Proposed Revisions to a Standard Plans Index

Index Number: 700-120
Sheet Number (s): AII

Index Title: Enhanced Highway Signing Assemblies

FY 2023-24 STANDARD PLANS INDEX

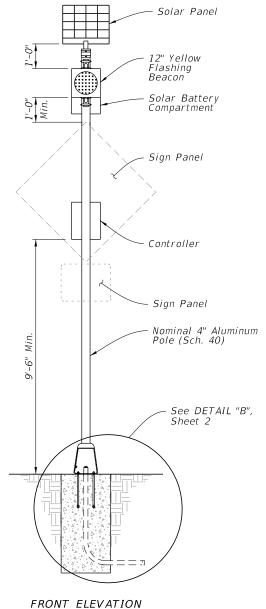
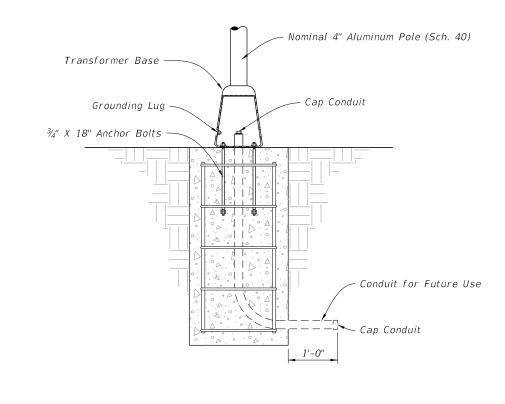
ADDED NEW SHEETS

SPREAD FOOTING FOUNDATION

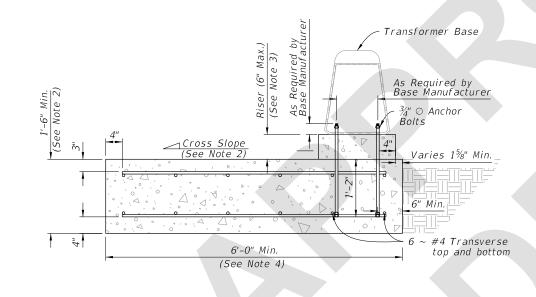
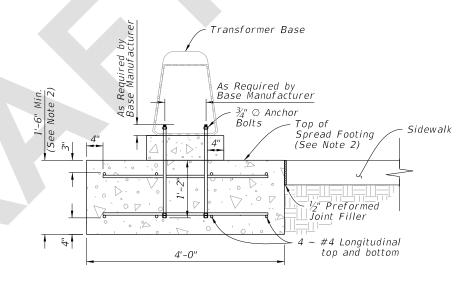
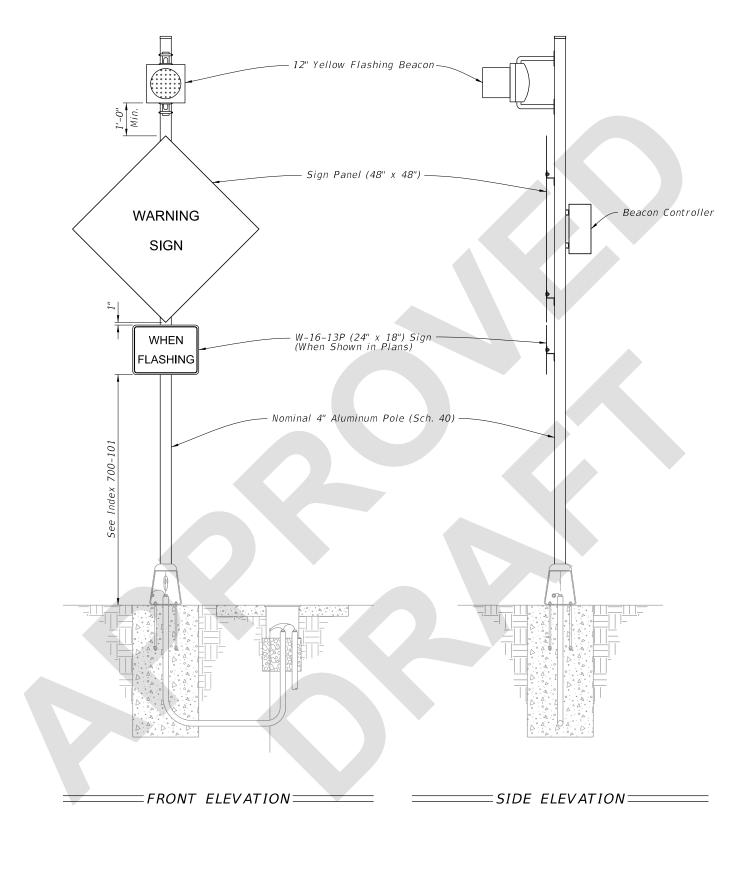
Sheet 1: Added New Sheets to Table of Contents. Sheet 3: New Sheet - Spread Footing Foundation. Sheet 12: New Sheet - Roadside Sign Assembly-9. Sheet 13: New Sheet - Roadside Sign Assembly-10. Sheet 14: New Sheet - Roadside Sign Assembly-11.

The districts have requested a spread footing foundation option be added.

- 1. Install the Spread Footing Foundation only where called for in the Plans.
- 2. SIDEWALK:
 - a. When abutting sidewalk, match the cross slope of the adjacent sidewalk or curb ramp where applicable. Maintain the minimum depth of footing.

- b. $\frac{1}{2}$ " expansion preformed joint filler required between sidewalk and spread footing.
 - c. Apply concrete surface finish to the top of the spread footing in accordance with Specification 522-7.

- d. Sidewalk placed on the other side or both sides of the spread footing is permitted where shown in the Plans.
- 3. Only use concrete riser when installed in-line with sidewalk curb that results in a drop off to the adjacent sidewalk.

- 4. For sidewalks greater than 6', match sidewalk width. Add one #4 transverse bar, top and bottom, per additional foot of spread footing to maintain at minimum the same reinforcement area per foot.

- 5. Base location can vary on spread footing. Location shown in Plans.

ROADSIDE SIGN ASSEMBLY-9

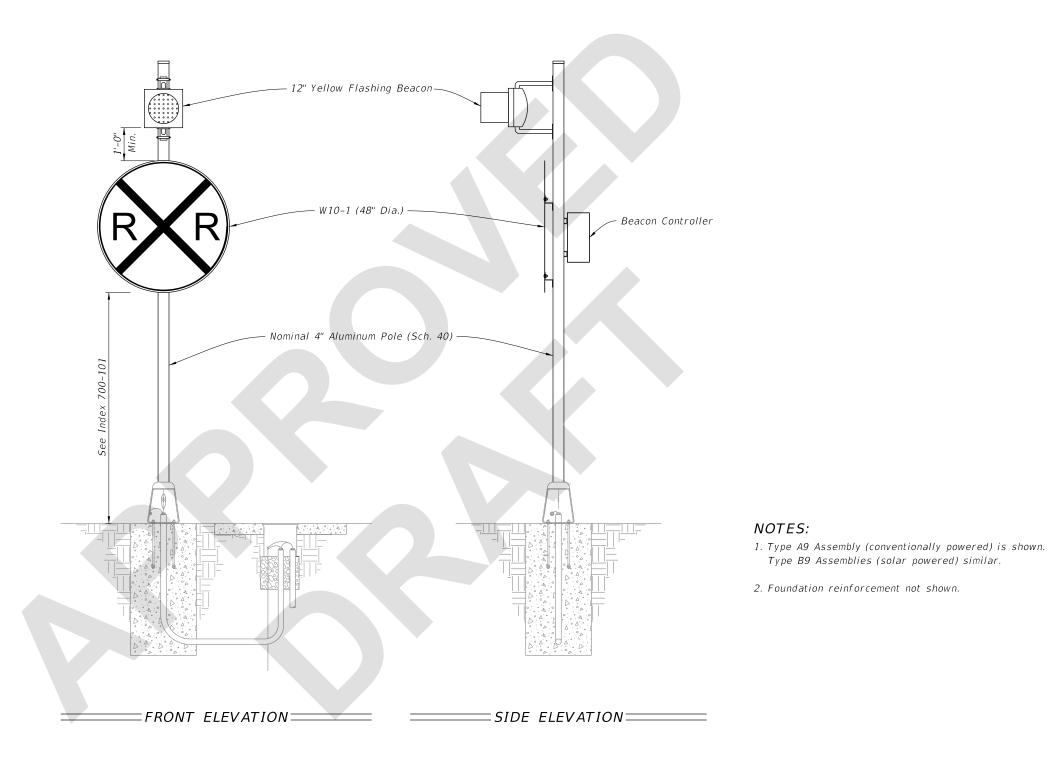
Three new Railroad Highlighted sign assemblies are being added as a result of input from the Rail Safety Task Team.
